NRC Safety Significance Assessment Team Report on allegations related to the South Texas Project, Units 1 and 2

Docket Nos. 50-498 and 50-499

Houston Lighting and Power Company

March 1988

Figure 5.1-2 Feedwater Pipe Shock Suppressor (FW-9012-HL 5005)
Attached to Reactor Coolant Pipe Rupture Restraint
(RC1125R1)

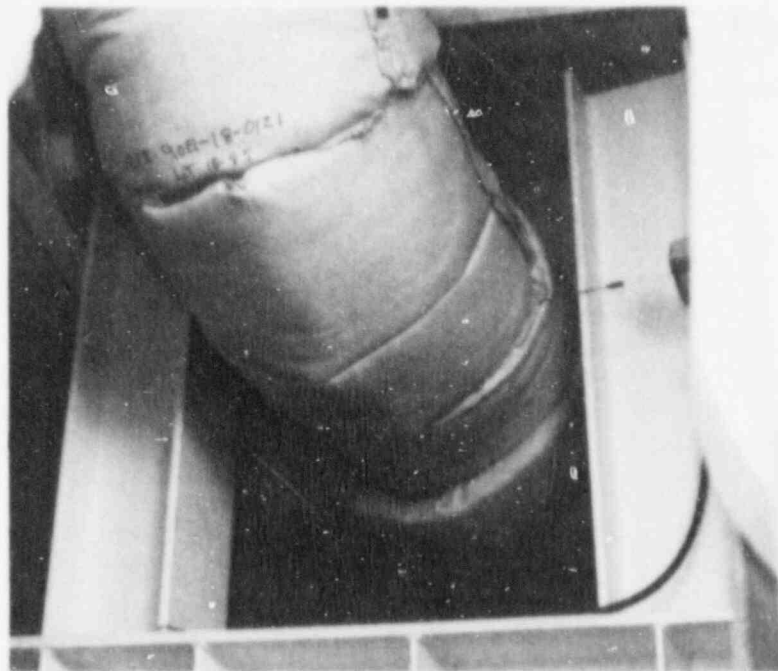
The SSAT reviewed the reactor coolant pipe whip restraint design drawing RC-1125-R1 and all associated design documentation for the large-bore pipe supports that have remained attached to the pipe whip restraint structure. The large-bore pipe support design drawings reviewed were FW-9012-HLS011, Revision 1, and RC-9125-HL5007, Revision 4. The SSAT performed a field walkdown to assure that the subject supports were the only two large-bore attachments to the pipe whip restraint. The SSAT also inspected, in a limited way, the as-built configuration of the large-bore supports to verify items such as utilization of correct material, support location and orientation, load settings, heat numbers, and material traceability (see Figures 5.1-2 and 5.1-3). Each of these areas was found to be acceptable. In addition, this information coincided fully with the documentation provided in the applicable N-5 code data reports reviewed by the SSAT.

While reviewing the design drawing for the pipe whip restraint, the SSAT noted note 7 which stated that: Based on the revised analyses, the pipe whip restraints defined on the drawing were not required; the pipe whip restraint support structures that are already erected may be left in place, provided that the constructor document completion of the structural erection and successful acceptance inspection of the completed work through established procedures; and structures that are partially erected or questionable because of uncertain completion, or not documented as completed and inspected, shall be removed.

However, the SSAT also noted a revision to the drawing that added note 5 which stated that no additional attachments are to be made to this (pipe whip) restraint. The SSAT informed HL&P that this note could be misinterpreted by other engineering disciplines and should be removed or revised to restrict attachments unless approved by civil/structural engineering personnel. Before the end of the inspection, the Civil/Structural Department reviewed all design drawings for Units 1 and 2. No other notes of this type were found, and the above note was corrected; this was verified by the SSAT.

The SSAT determined that this allegation was not substantiated. The design documentation that was developed to remove the structure as a pipe whip restraint was adequate as well as the design documents and code data reports for the attached feedwater pipe supports.

Figure 5.6-1 Raychem Splices

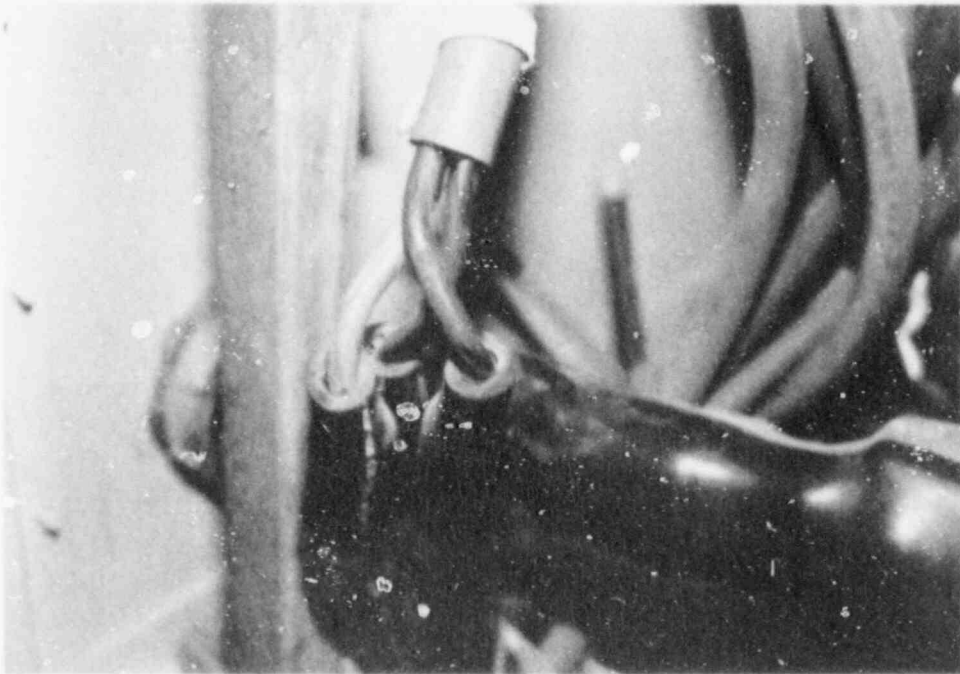
The SSAT also examined the splices on the inboard and outboard sides of electrical penetration EPA-17 on STP Unit 1 (see Figure 5.6-1(a) and (b)). Additionally, two terminal boxes in the Unit 1 reactor containment building were opened and the SSAT inspected the Raychem splices. The SSAT observed the following items and found them to be acceptable:

Pursuant to 10 CFR Part 50.55e, HL&P notified the NRC on March 1, 1988 that six Raychem cable splices were installed incorrectly. Two members of the SSAT visited the STP facility between March 4 and March 8, 1988, to review the significance of these findings, determine the root cause, and assess the generic implications.

The SSAT determined that 91 (of approximately 2300) Raychem splices were identified as having been excluded from earlier reinspections performed by HL&P. As a result of a reinspection of the 91 splices, 3 were identified as needing rework and another 3 splices were identified as marginal. The SSAT determined that all 6 splices had been reworked by HL&P.

Before ascension from 5% power for Unit 1, HL&P shall complete all modifications concerning the corrective action program implementing procedures in accordance with the above discussion.

Figure 5.6-4 Flexible Conduit Installations With Apparent Bend Radius Violations

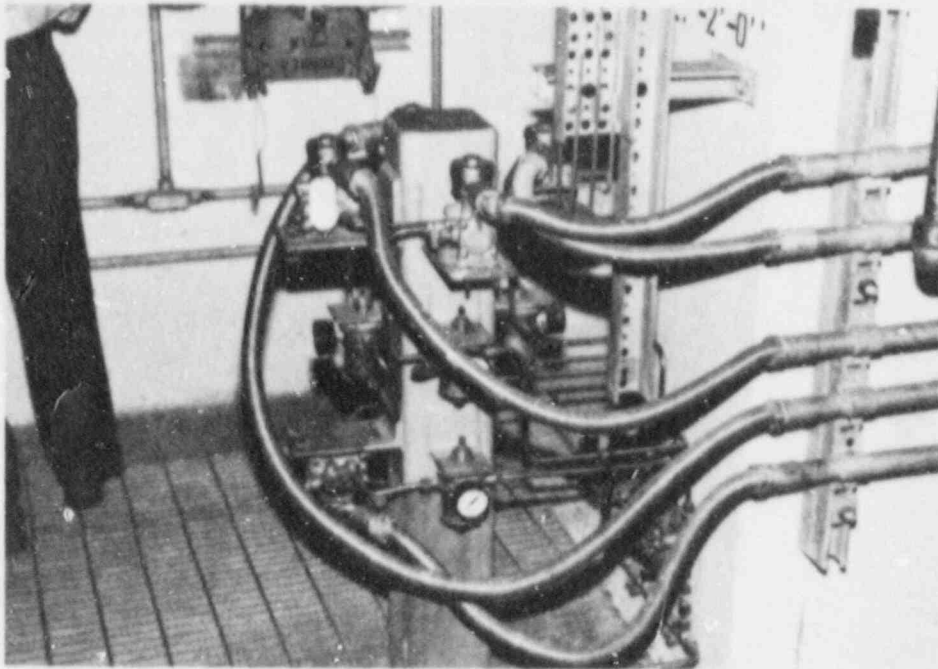
- (3) At elevation 31 feet in the Unit 1 mechanical and electrical auxiliary building (MEAB), room 106A, the conduit leading to a Limatorque-type motor-operated valve was in a passageway and could be potentially damaged. This installation had been inspected and NCR CE05256, dated December 12, 1986, identified that the permanent identification tag was damaged and the flexible hose was broken. The tag was replaced and was verified to be acceptable on April 21, 1987. Design change notices (DCNs) 4 and 5 were initiated to rotate the valve actuator by 180° to remove it from the passageway. The valve is scheduled to be rotated during the first refueling outage.

- (4) At elevation 10 feet in room 035 in the MEAB, Unit 1, the bend radius for an FMC on instrument DICB-TSH-00240 was found to be 4 inches. This condition was dispositioned and found acceptable, since the MBR of the cable within the conduit was 1.8 inch.

Figure 5.8-2 Area Under Lamp Maintenance Access on Polar Crane Catwalk With Taped Areas Not Coated

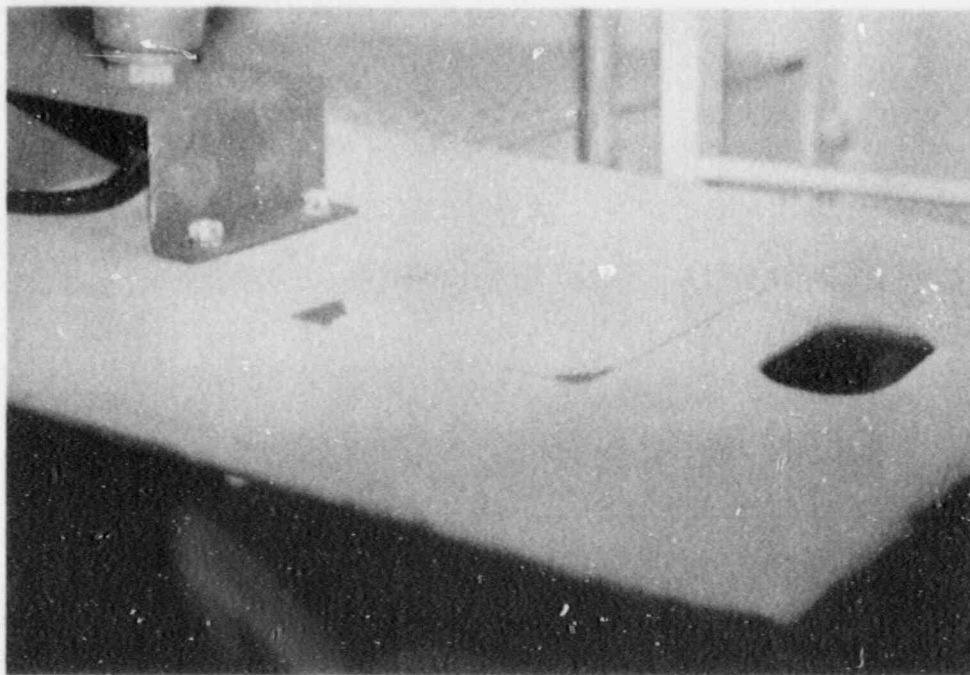
One small (9-inch x 12-inch) area under a lamp maintenance/access plate on the polar crane catwalk was found by the SSAT to be improperly coated (see Figure 5.8-2). The area had been taped before application of the topcoat, possibly as the attachment point for the lamp. However, when the lamp was attached in another location, the tape was not removed and the area was not topcoated. There were also several small areas under the girders above the trucks for the crane where the topcoat had not been applied. It appears that the girder had been resting on blocks in this area when the topcoat had been applied. The SSAT determined that the proper thickness of inorganic zinc primer was found in these areas.
